STAFF RECOMMENDATION 2507 Belmont Boulevard August 17, 2016

Application: New construction- addition; Partial demolition
District: Belmont-Hillsboro Neighborhood Conservation Zoning Overlay
Council District: 18
Map and Parcel Number: 11704002300
Applicant: Tyler LeMarinel, Allard Ward Architects
Project Lead: Melissa Sajid, melissa.sajid@nashville.gov

Description of Project: The request is to construct rear addition. The request also includes demolishing a non-contributing addition and changes to windows on the right side of the historic house.

Figure 2: 1914 Sanborn map

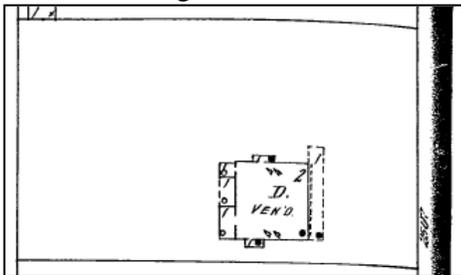
Demolition: The request includes demolishing an existing, non-contributing rear addition that has a footprint of approximately four hundred and thirty-eight square feet (438 sq. ft.). The 1914 Sanborn maps indicate that the rear addition that is to be removed is not original to the house (Figures 2 and 3). Staff finds that demolition of the existing rear addition is appropriate as it is not original to the house, located at the rear, and is not a character defining feature.

1 Site plan
 Scale: 1/8" = 1'-0"

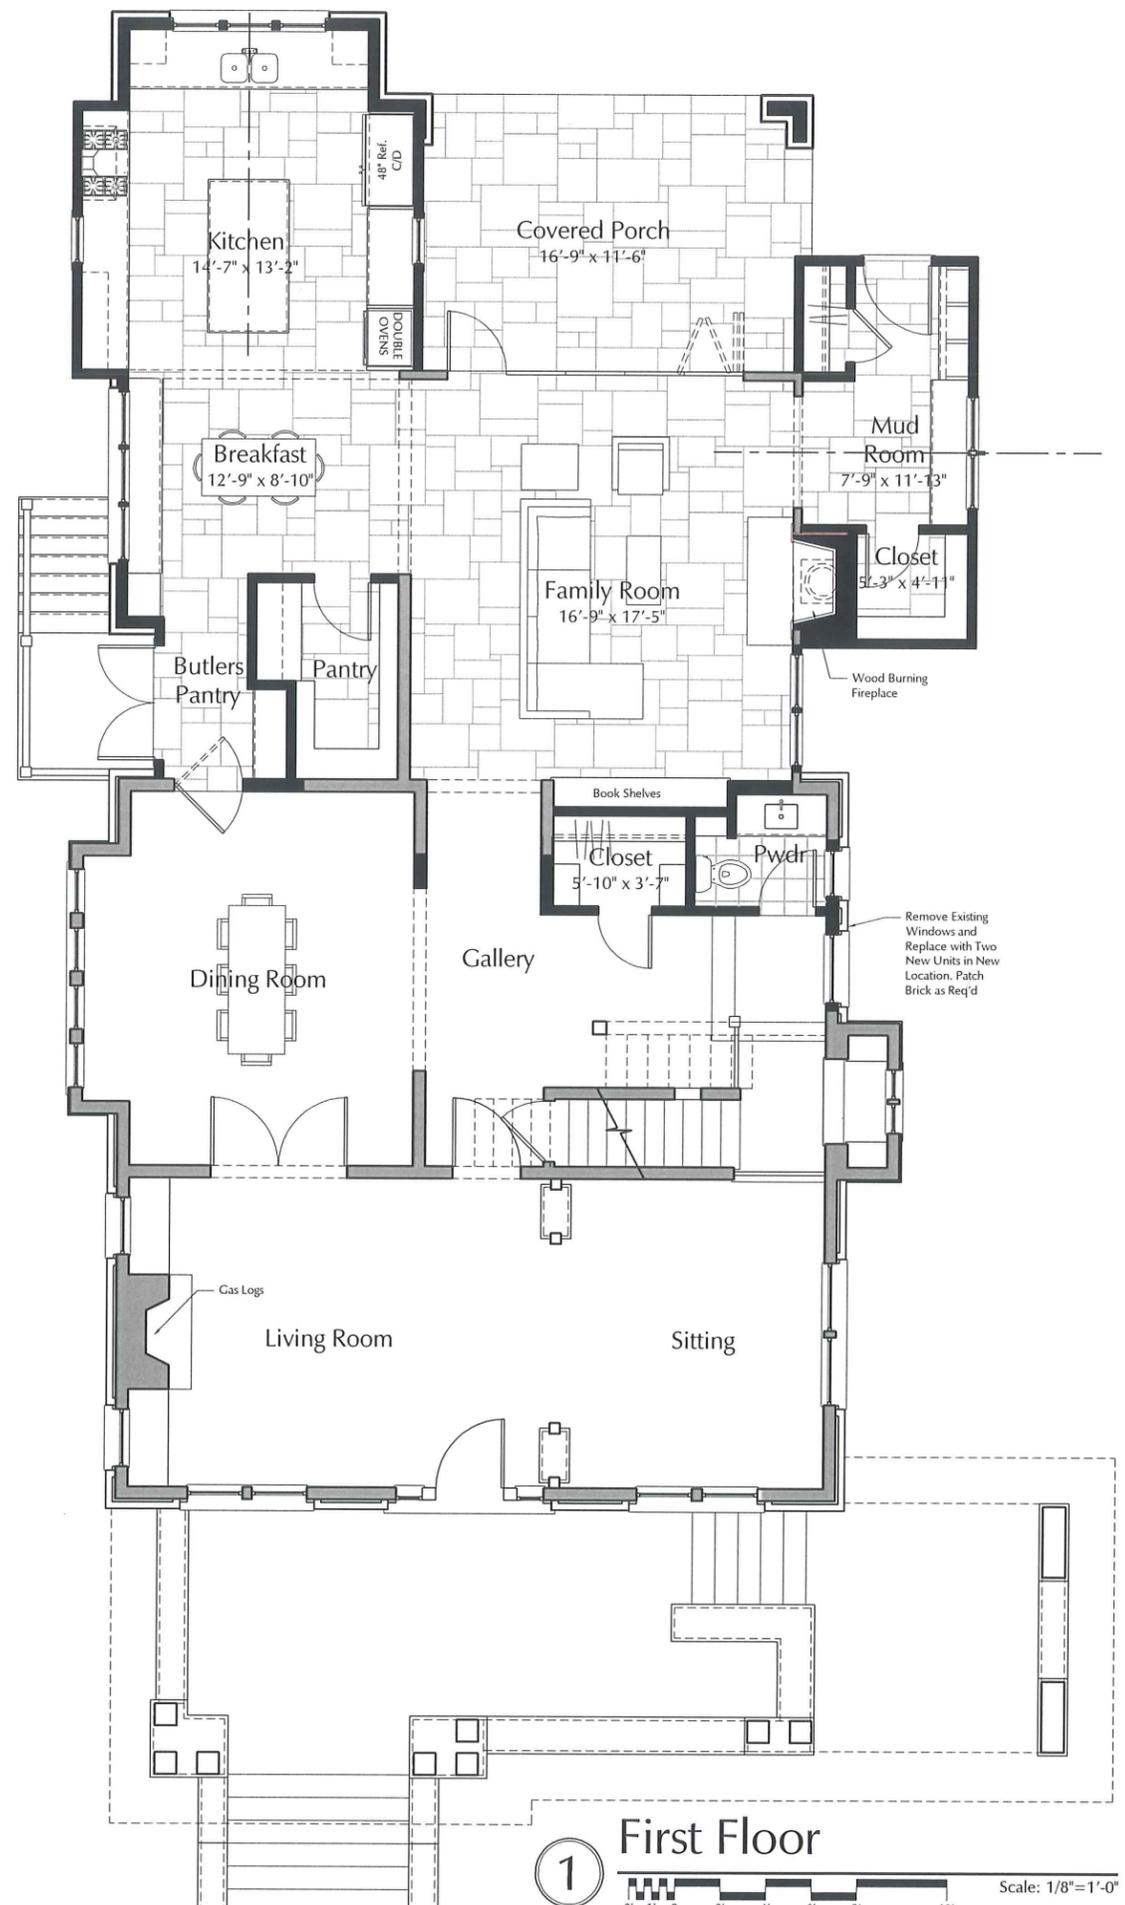
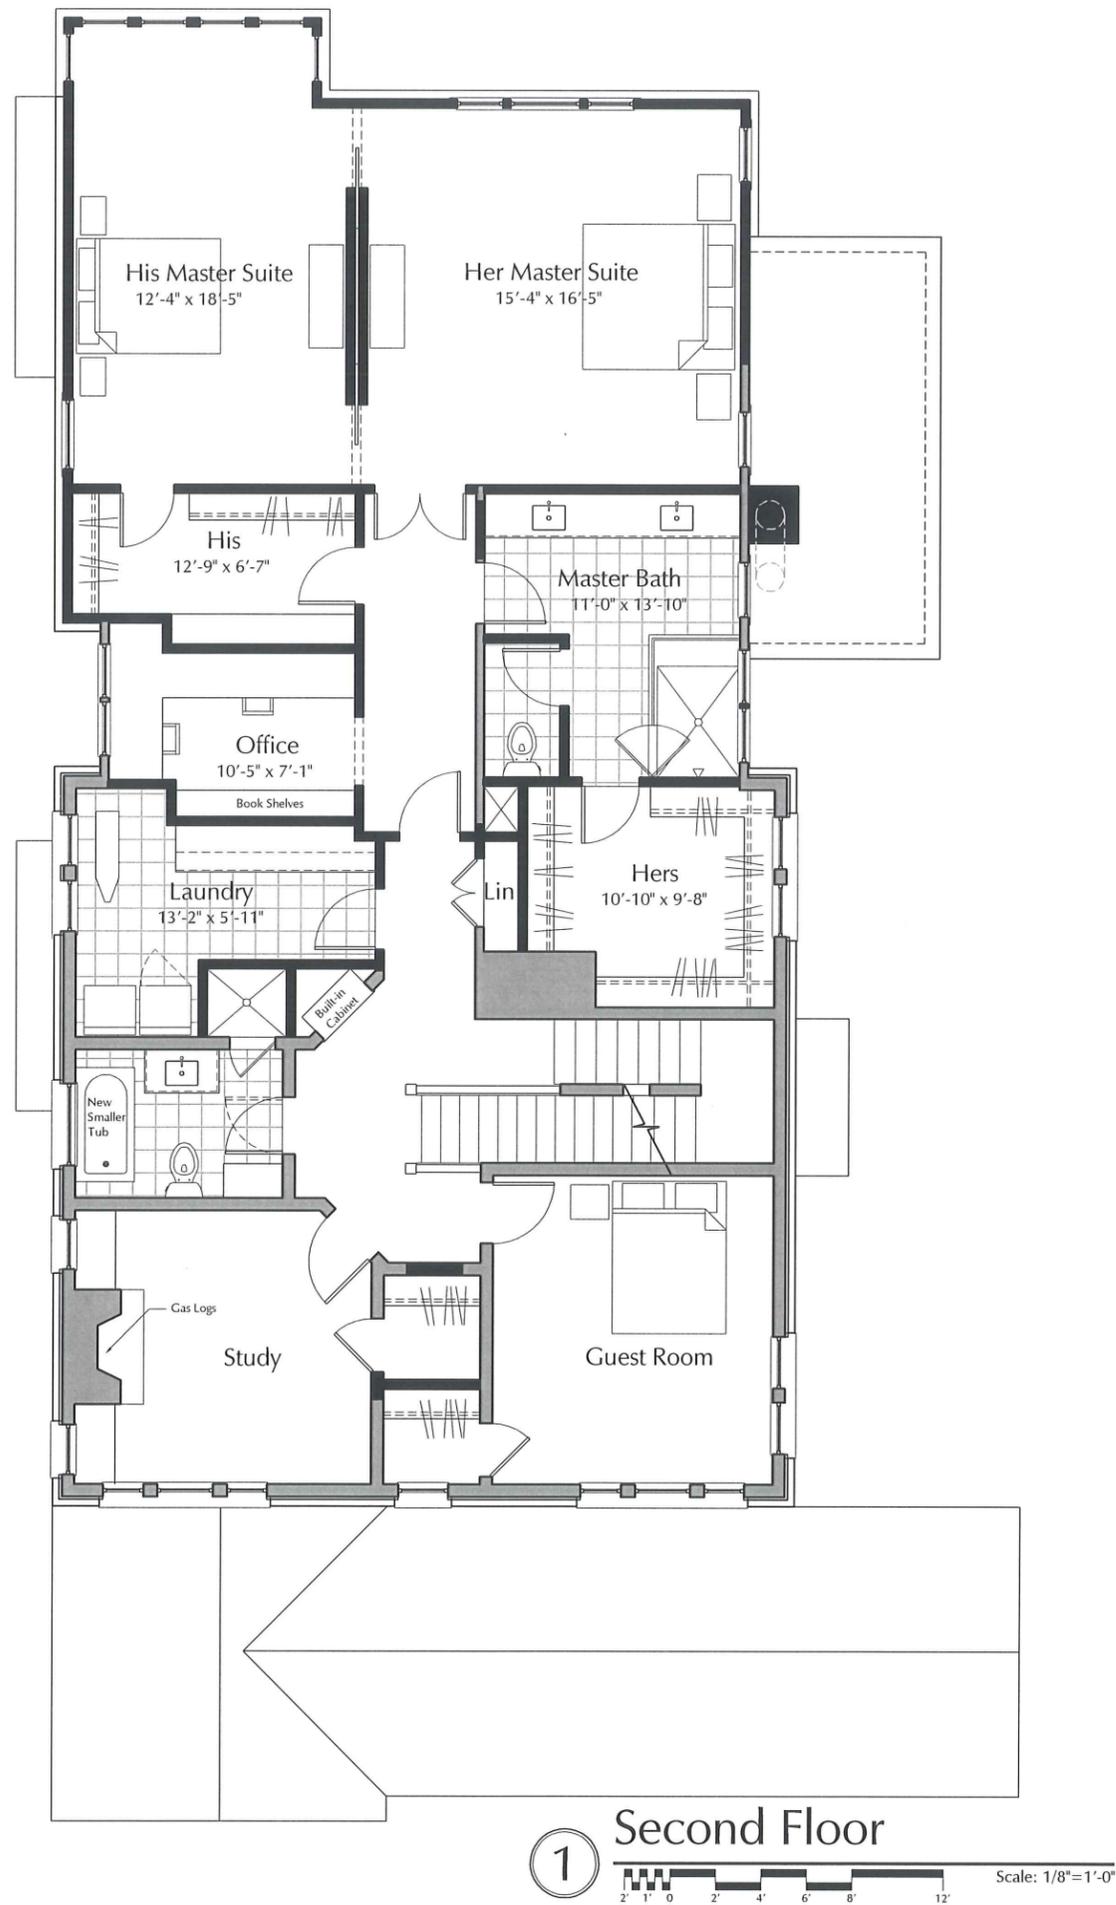
Design, Location & Removability: The new construction is located at the rear of the historic house, in accordance with design guidelines. As proposed, the addition is inset two feet, one and one-half inches (2'-1 1/2") from the rear corner on the right side where the addition is single-story and two feet (2') on the left side where the addition is two-stories. The addition meets the design guideline that requires the construction to be inset one foot (1') per story from the rear corners of the historic house.

Setbacks: The new addition meets all setbacks required by the base zoning. The addition is located approximately fifty-seven feet (57') from the rear property line, five feet (5')

from the right side property line, and ten feet, three inches (10'-3") from the left side property line.

A1.1

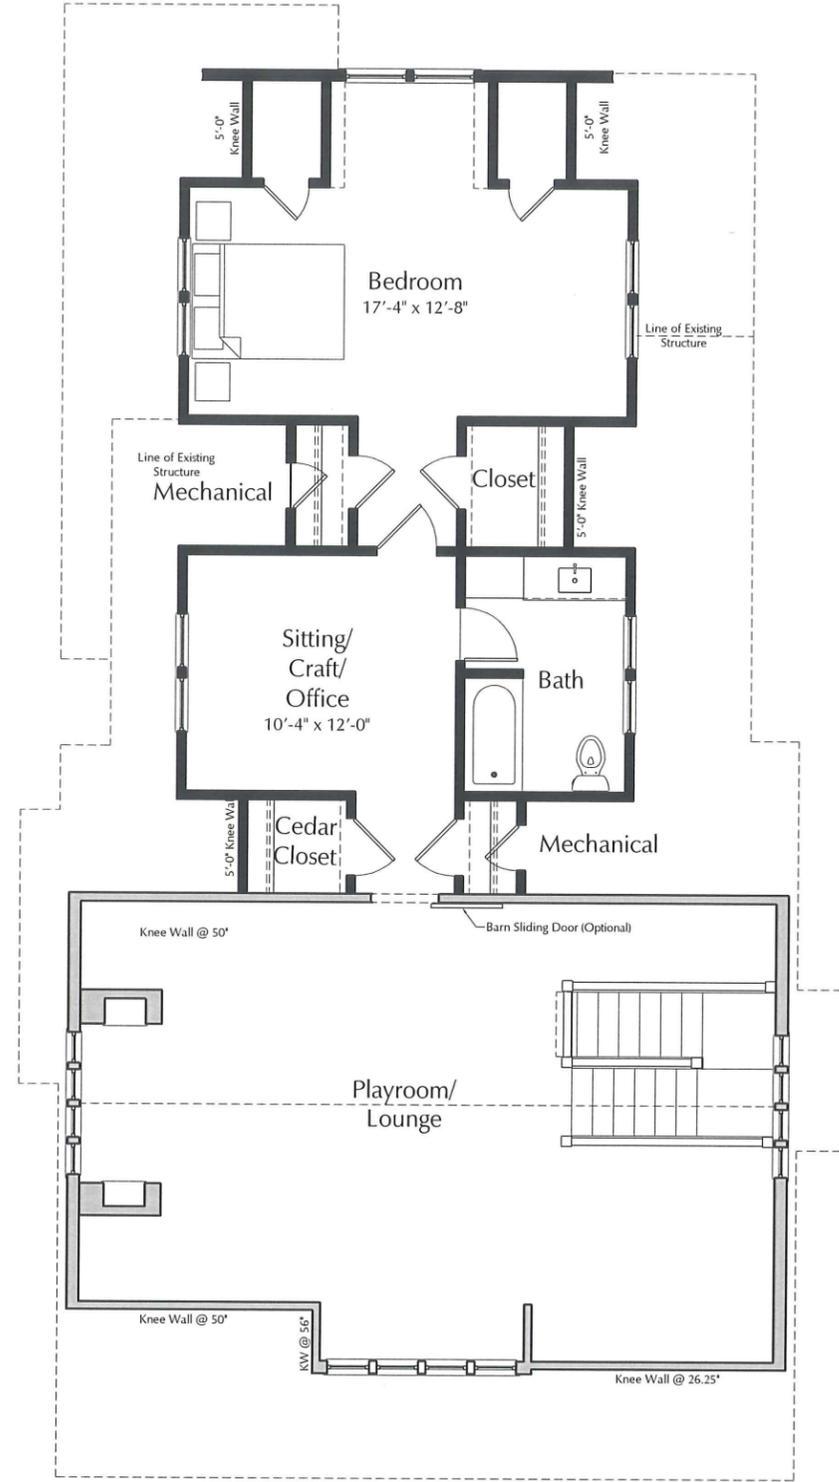
The request also includes removing the existing double-hung paired windows on the right side of the historic house and replacing them with a single double-hung window and a smaller window. The windows to be altered are located near the rear of the right side of the historic house, behind the existing bay window. Staff finds that altering the windows could be appropriate since they are located near the rear of the historic house and unlikely to be seen from the street as they are behind the existing bay window which projects out from the side wall approximately two feet (2') (Figure 4).

Remove Existing Windows and Replace with Two New Units in New Location. Patch Brick as Req'd

Staff finds that the demolition of the non-contributing addition and proposed alteration of the windows on the right side of the house are appropriate and meet Section III.B.2 for appropriate demolition and does not meet section III.B.1 for inappropriate demolition.
